SUBDIVISION REVIEW SHEET

CASE NO.: C8-2012-0093.0A

SUBDIVISION NAME: Zilker Hill's; Resubdivision of Lots 4 & 5

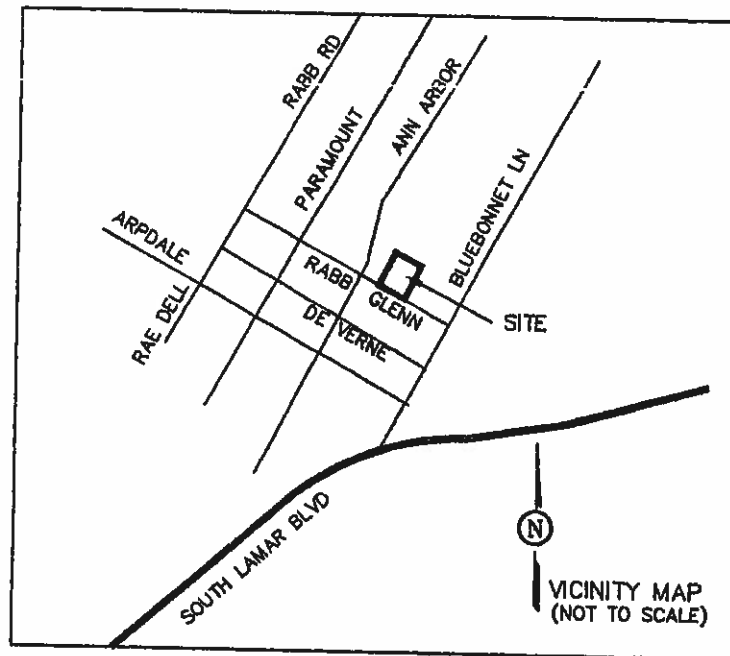
DEPARTMENT COMMENTS: The request is for approval of the Zilker Hills; Resubdivision of Lots 4 & 5. The proposed plat is composed of 4 lots on .796 acres.

STAFF RECOMMENDATION: The staff recommends disapproval of the plat. This plat does not meet all applicable State and City of Austin LDC requirements.
